PLANNING, DEVELOPMENT AND INFRASTRUCTURE ACT 2016

Development Number: 26016431

Applicant: ElectraNet and Australian Naval Infrastructure

Nature of Development: Construction of new and expanded substations, relocation and undergrounding of 275kV electricity transmission lines, and tree damaging activity

Figure 1: Comparison of URPS and Succession Ecology advice, from Facebook post by Alex Laratro

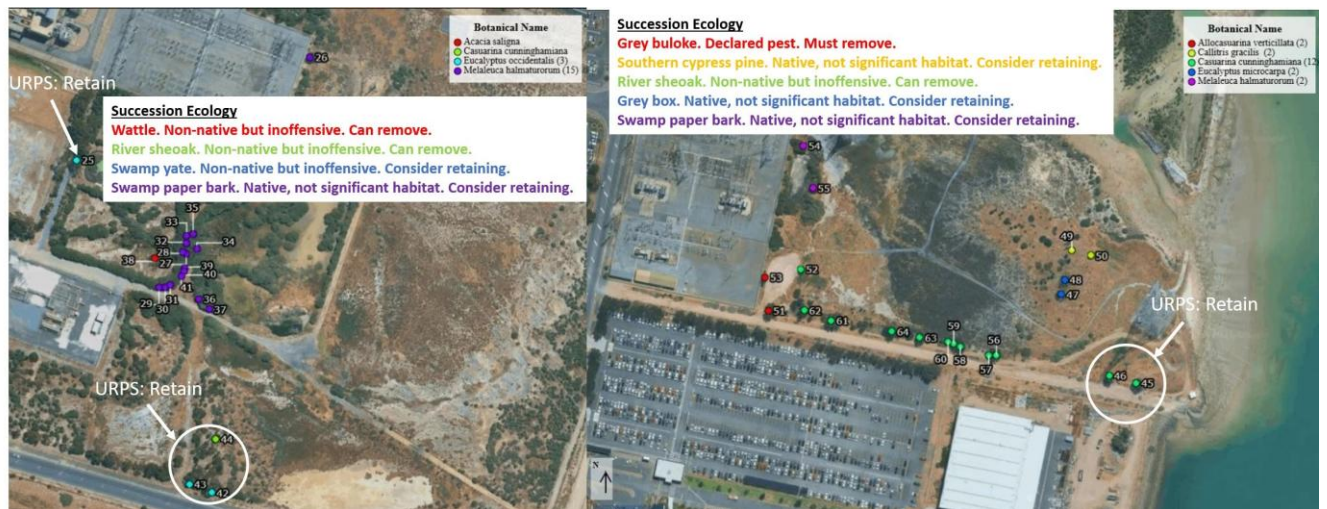
We were pleased that the Succession Ecology report was provided to SCAP so that we could consider their proposals for trees to be retained, compared to the advice from URPS.

ANI advise that ElectraNet have a dedicated budget for revegetation as part of their program and we suggest SCAP ask them to outline their plans and whether they will undertake replacement planting or pay into a relevant tree fund, and if so which one.

Figure 14: Existing vegetation south of SEA Gas pipeline

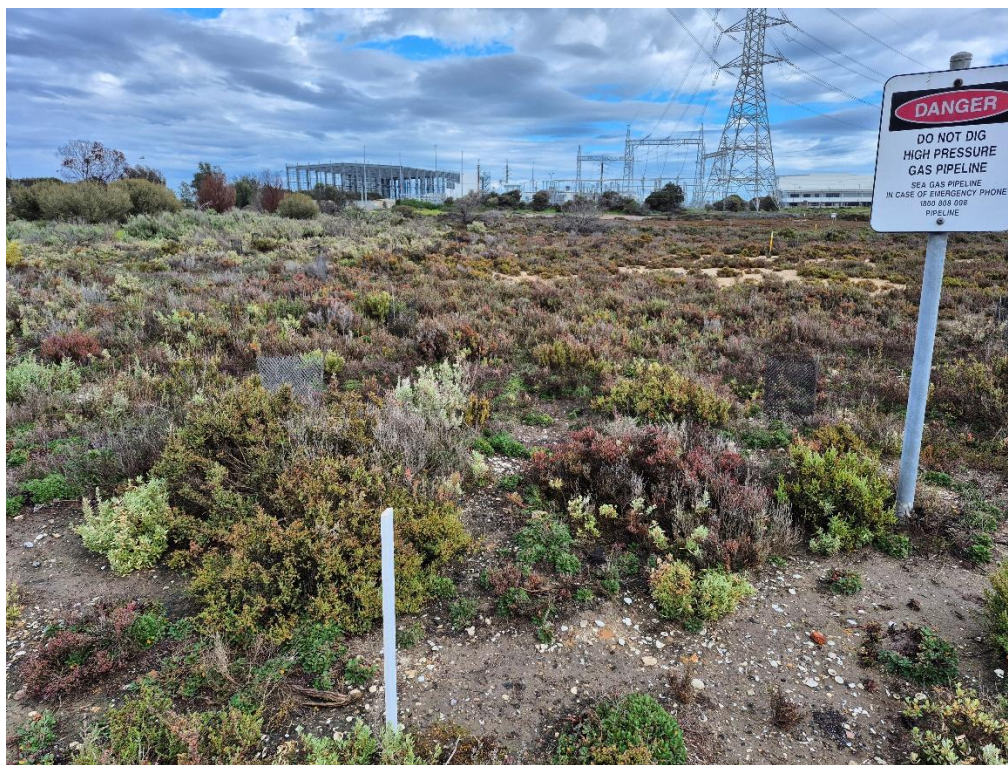
FPR suggest SCAP also needs to be advised about plans for any lay down area, and how it will be revegetated after the project. (Figure 14)
